# Access Compliance Report

## Public Rights-of-Way

### (Curb Ramps)

Intersection ID: 3675	Main Street: DAVIS_LAKE_PY	Cross Street: ELK_RUN_LN	Location: S
ADA ID: 60F860E16CA7	Ramp Type: Perp	Initial Pass/Fail: Fail	Overall Compliance: No
Severity Score: 13.75			
Codes/Mitigation Info/Possible Solution		Field Measurements/Component Compliance

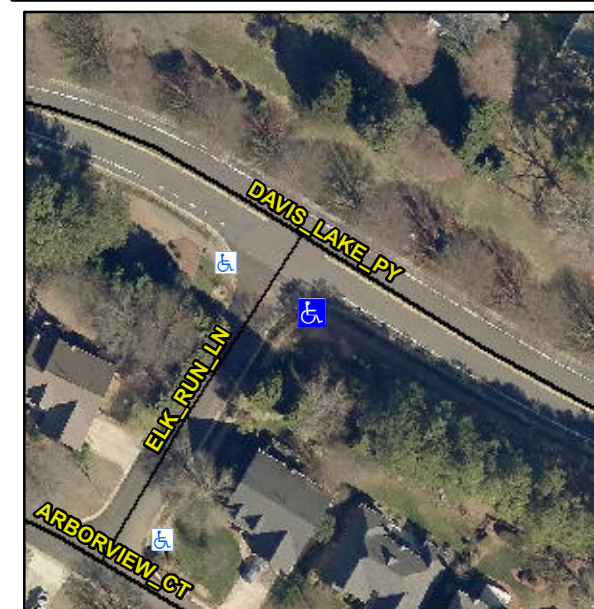
**Not Found, R304.2.2, R304.5.3**

Compliance	Description	Data	Compliance	Description	Data
N/A	Ramp Length (in)	50.0	No	Ramp Slope (%)	9.9
Yes	Ramp Width (in)	48.0	No	Ramp XSlope (%)	2.2
N/A	Flare Type LT	N/A	N/A	Flare Type RT	N/A
N/A	Flare Slope LT (%)	N/A	N/A	Flare Slope RT (%)	N/A
N/A	Flare Traversable LT?	N/A	N/A	Flare Traversable RT?	N/A
N/A	Landing Length (in)	N/A	N/A	DWS Provided?	N/A
N/A	Landing Width (in)	N/A	N/A	DWS Contrast?	N/A
N/A	Landing Slope (%)	N/A	N/A	DWS Length (in)	N/A
N/A	Landing X Slope (%)	N/A	N/A	DWS Full Width?	N/A
N/A	Landing Curb? (Y/N)	N/A	N/A	DWS Offset (in)	N/A
N/A	Shared Landing?	N/A			
N/A	Gutter Ponding?	N/A	N/A	Gutter Slope (%)	N/A
N/A	Gutter Lip Ht (in)	0.5	N/A	Gutter X Slope (%)	N/A
N/A	Painted X Walk1?	No	N/A	Painted X Walk2?	N/A
	X Walk 1 Direction	To NW		X Walk 2 Direction	N/A
N/A	X Walk 1 Width (in)	N/A	N/A	X Walk 2 Width (in)	N/A
	X Walk 1 Slope (%)	2.5		X Walk 2 Slope (%)	N/A
	X Walk 1 X Slope (%)	3.5		X Walk 2 X Slope (%)	N/A

**Remove & Replace Entire Ramp.**
